ECU00002175: Proposed Corriegarth 2 Wind Farm Supplementary Environmental Information (SEI): Response to Ironside Farrar Stage 1 Checking Report – Review of Peat Slide Risk Assessment

In reference to the above project, Arcus Consultancy Services Ltd (Arcus) has prepared this clarification letter in response to the Ironside Farrar Ltd Stage 1 Checking Report (the Checking Report) dated August 2022. This response supersedes the previous 'draft' version circulated on 28th September, and has been informed by discussion with Ironside Farrar and the Energy Consents Unit (ECU) on 30th September 2022.

Reproduced from Ordnance Survey digital map data © Crown copyright 2022. All rights reserved. License number 100048606

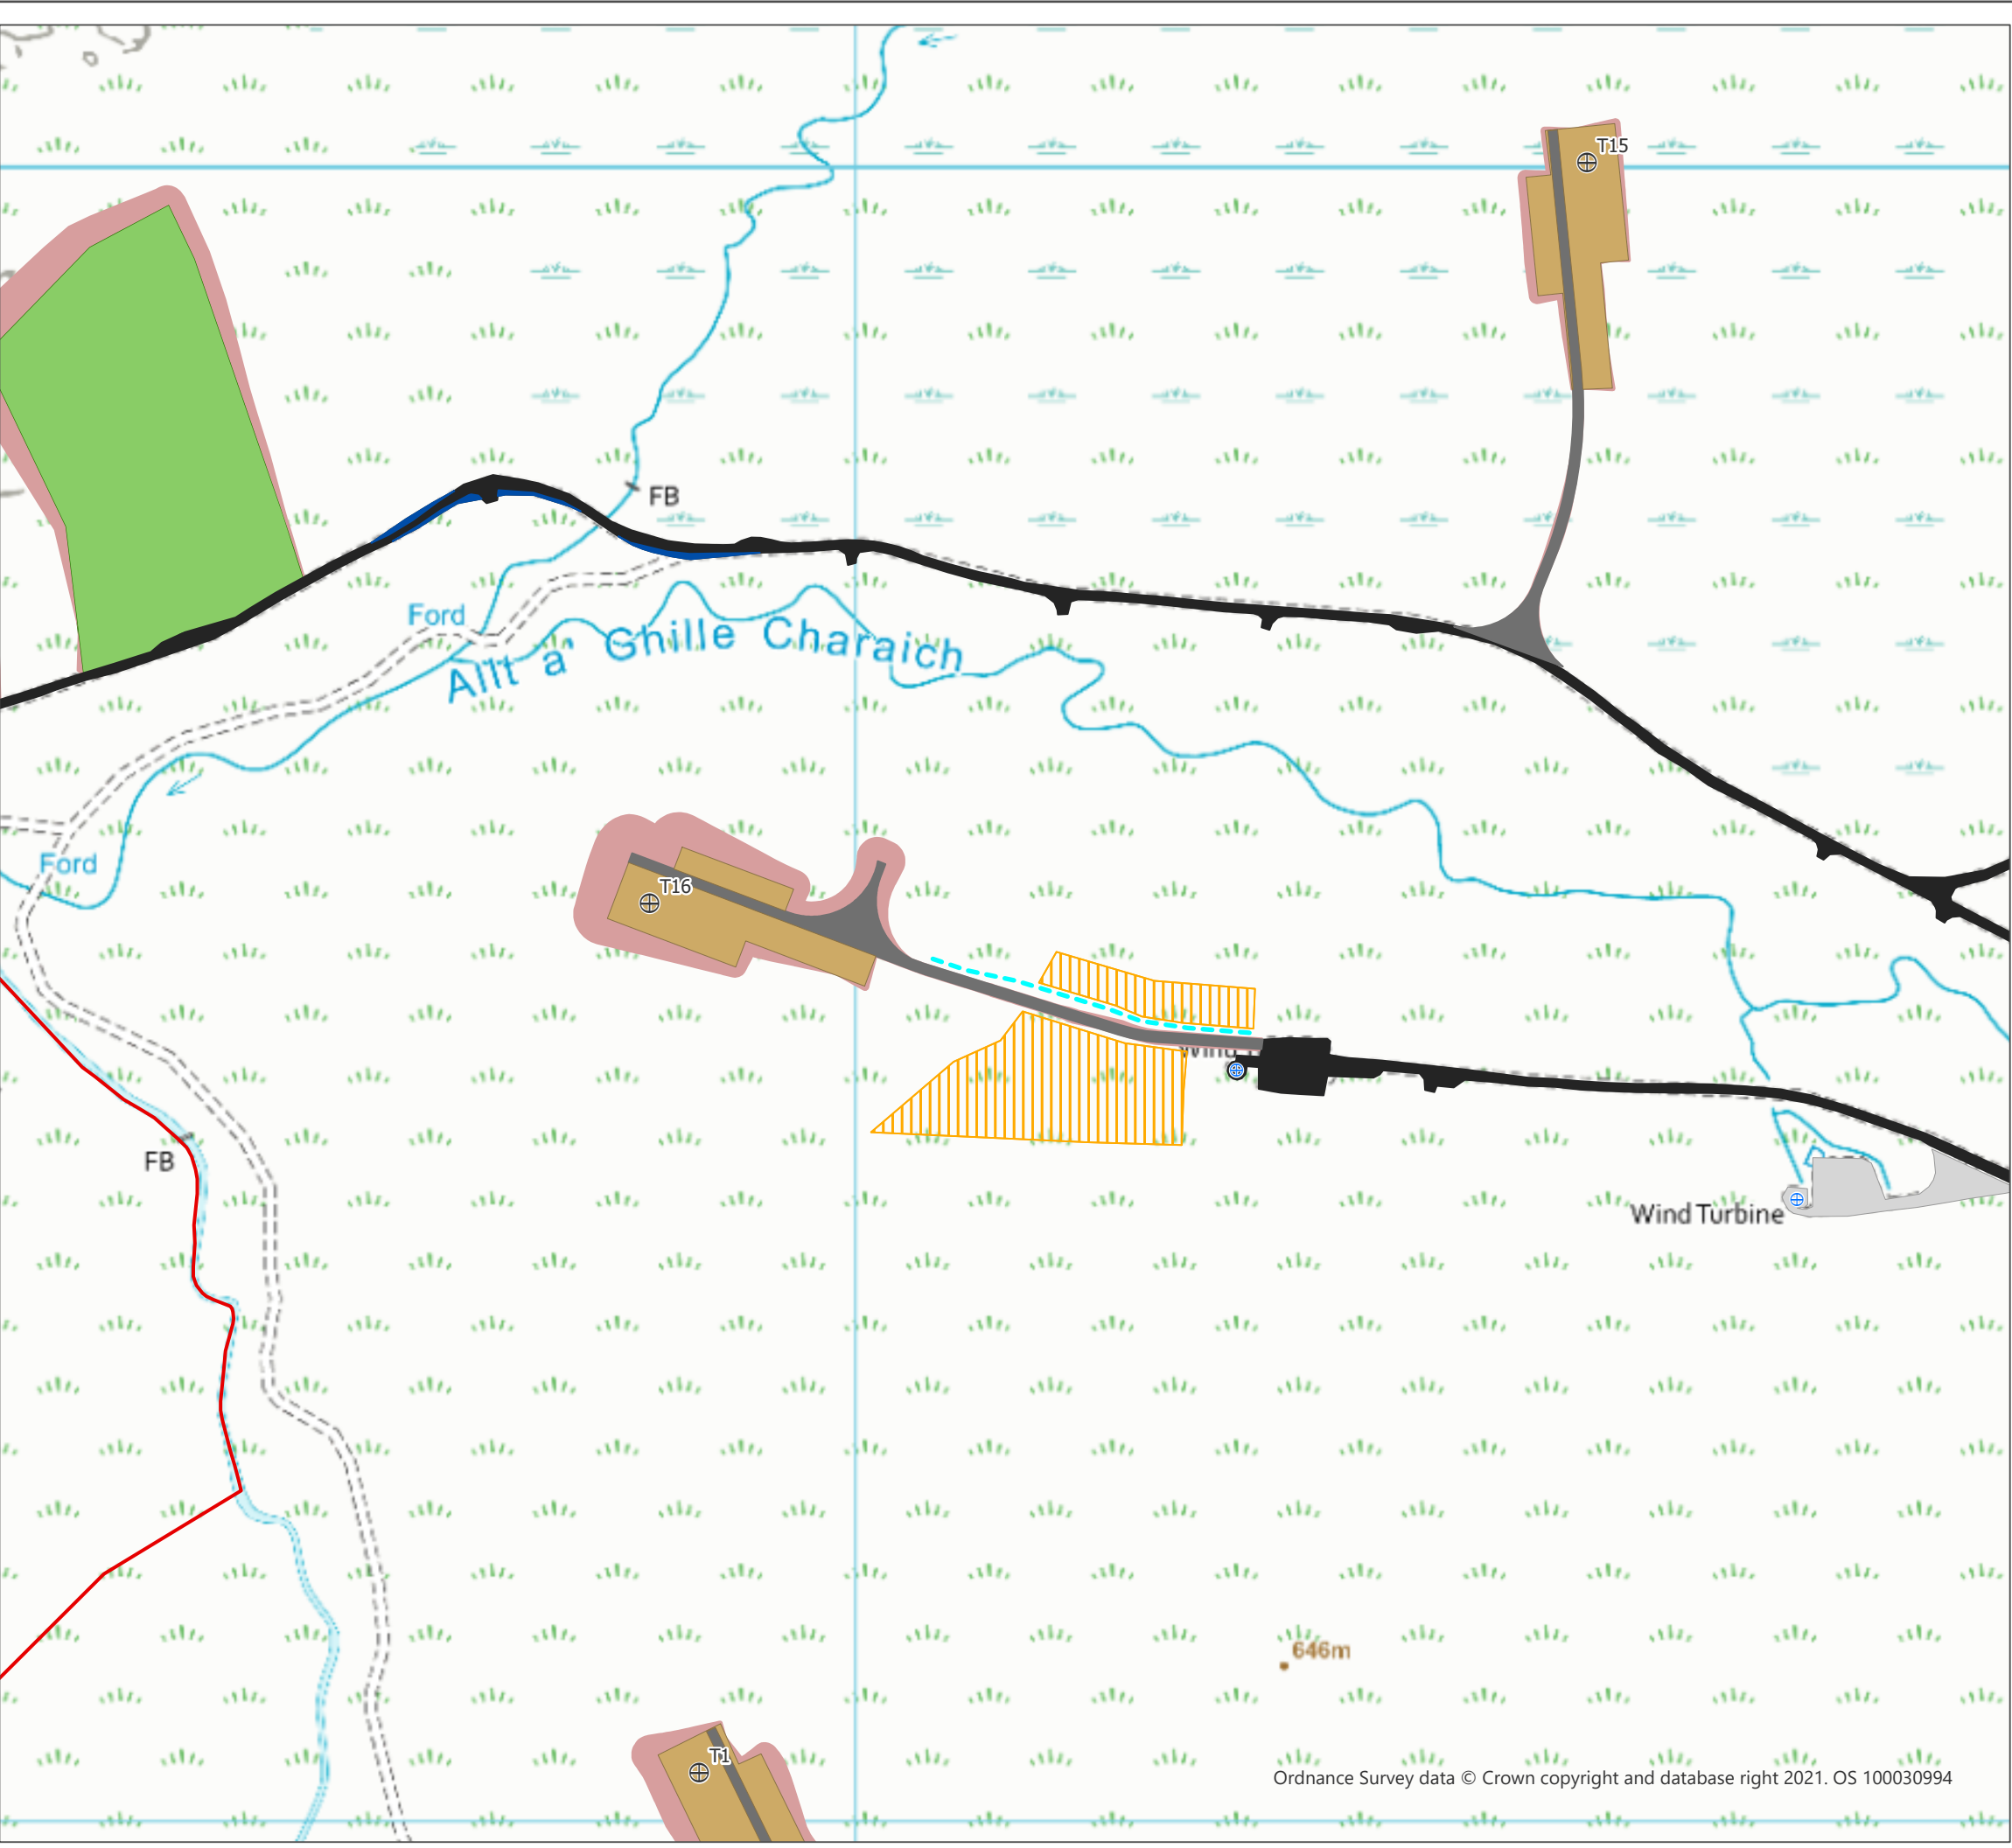
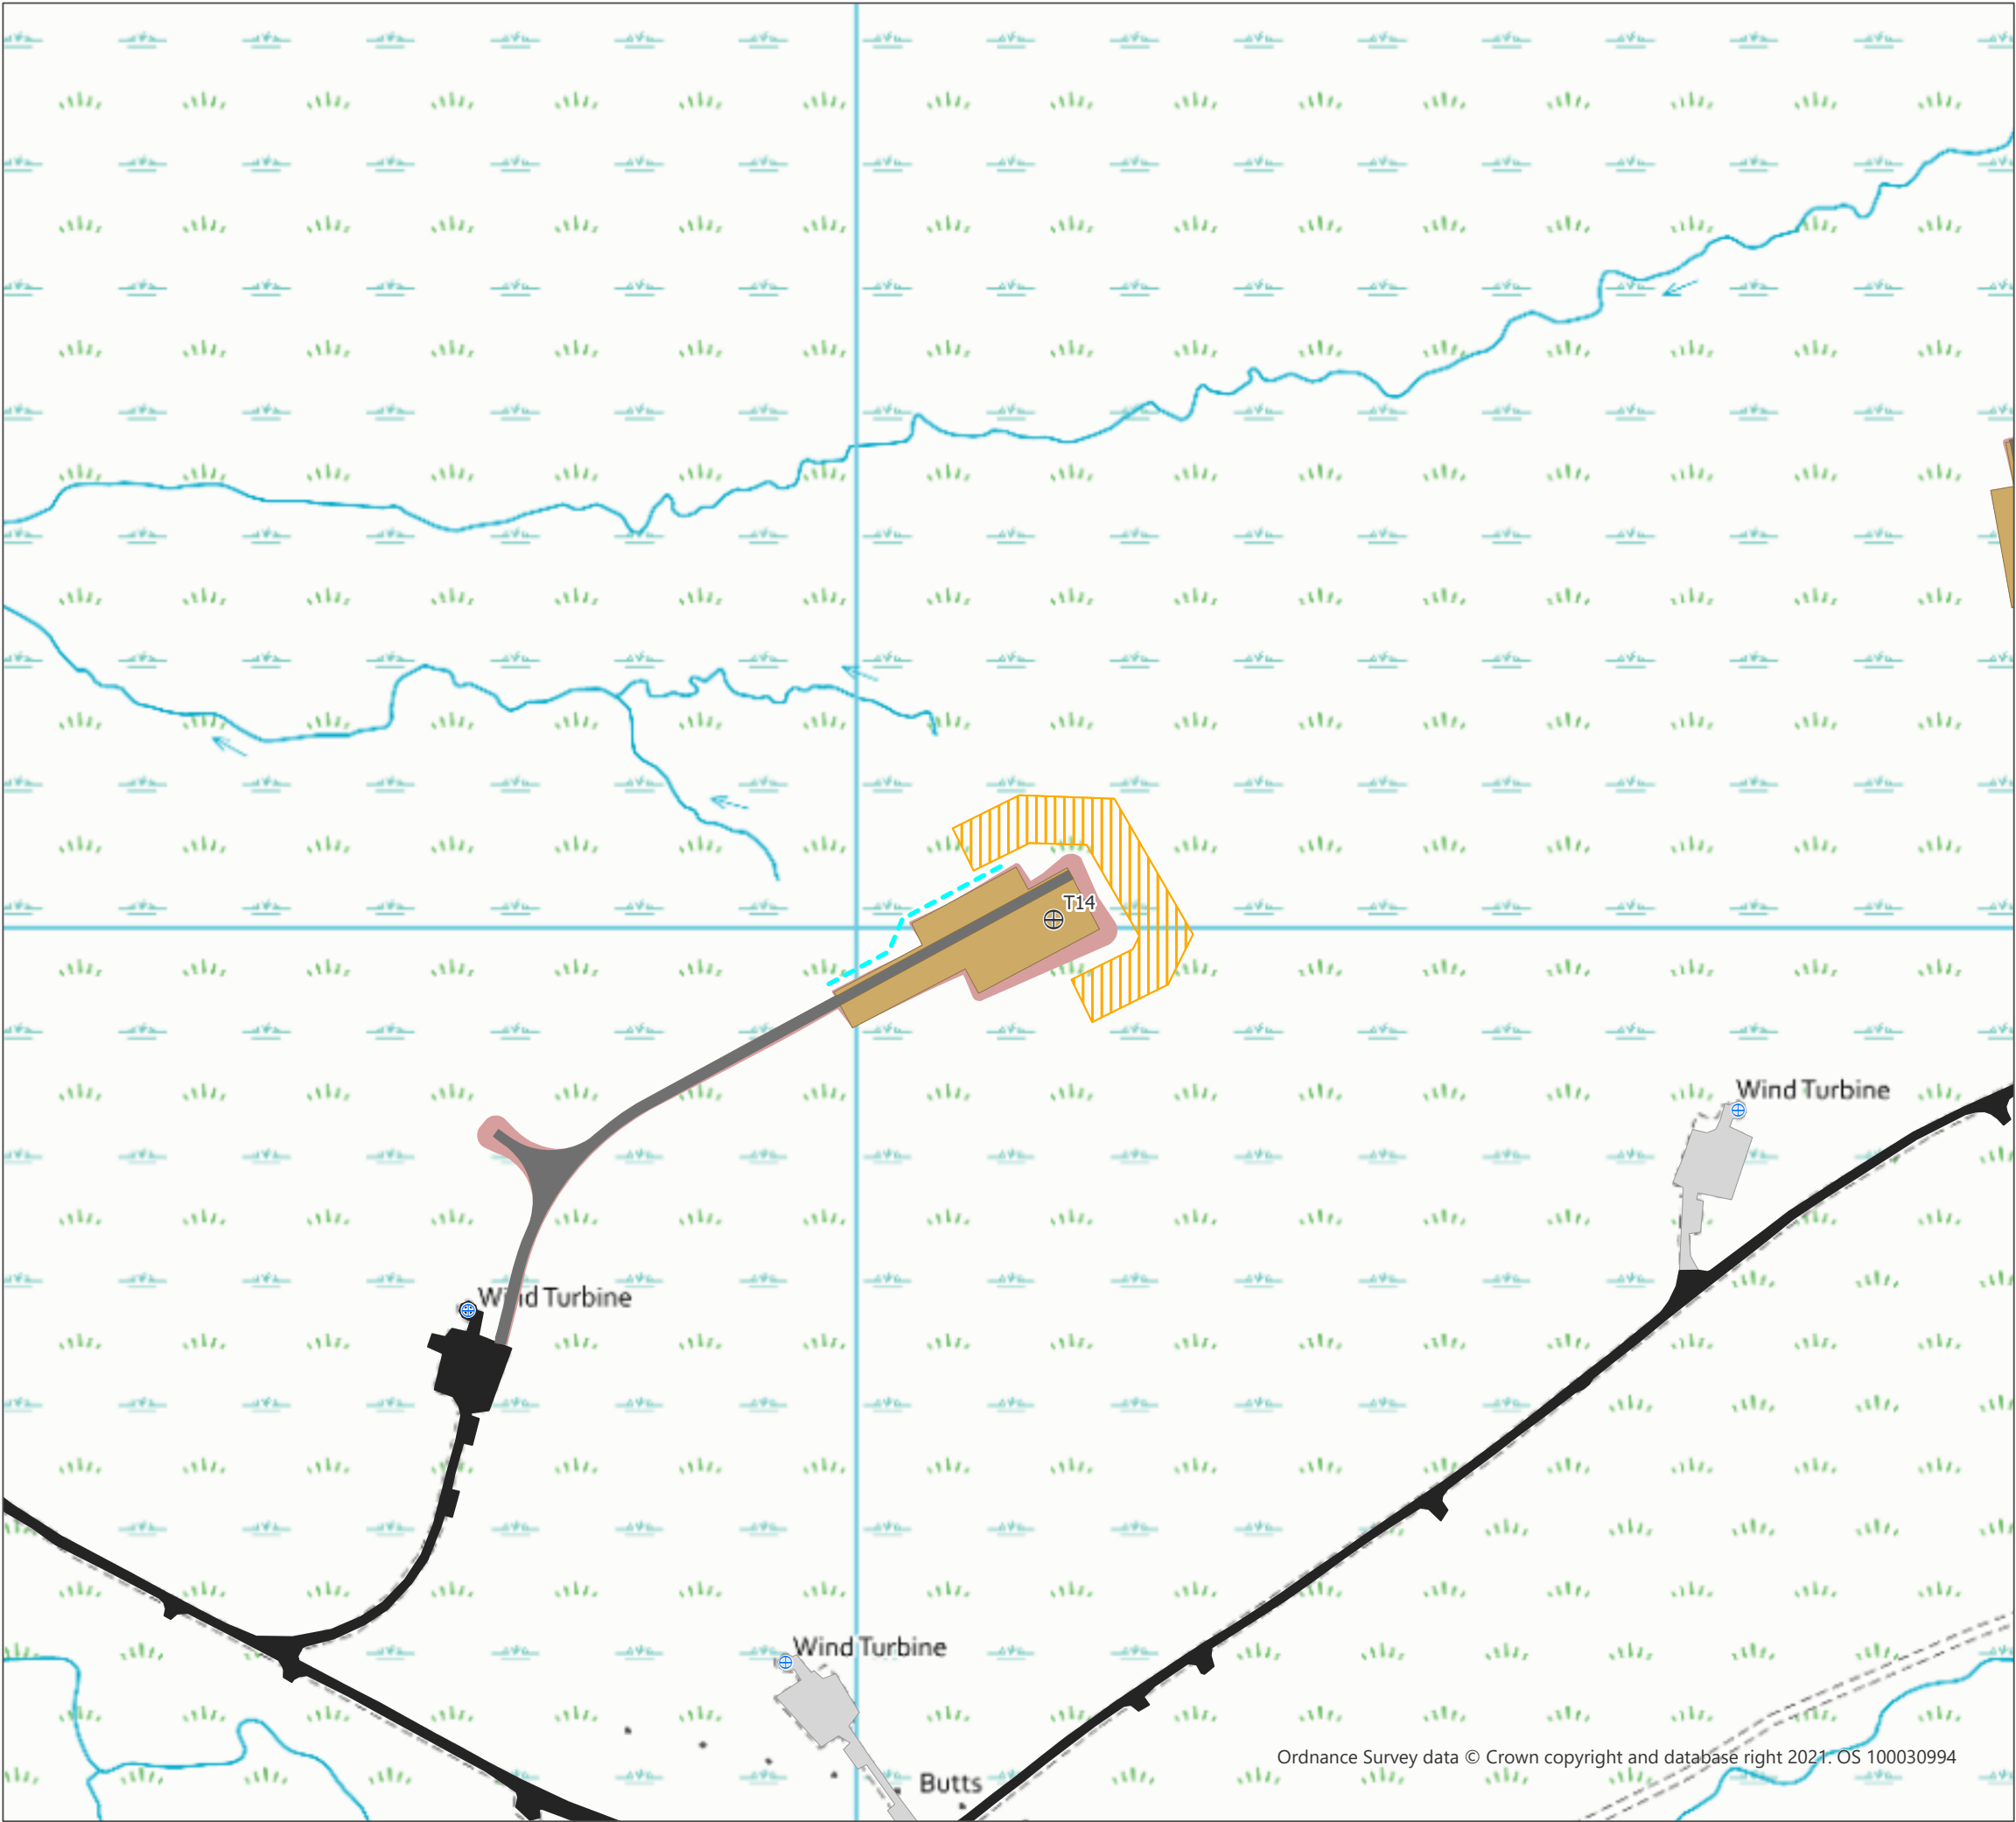
The mitigation provided in Table 15 is considered generic and not specifically targeted to the risks identified in the risk assessment. Further detail / clarification of practices is required particularly in the case of medium risk zones in order to satisfy the ECUBPG.

Proposed mitigation is illustrated on Clarification Figure 3 (and Figure 3a to 3d) included in Appendix A of this letter. These measures presented on Clarification Figure 3 are the minimum proposals that will be in place during construction, however intrusive geotechnical investigation and detailed design will inform the

Specific mitigation in the areas of medium risk hazard as identified on Clarification Figure 3 (and Figure 3a to 3d) includes the following:
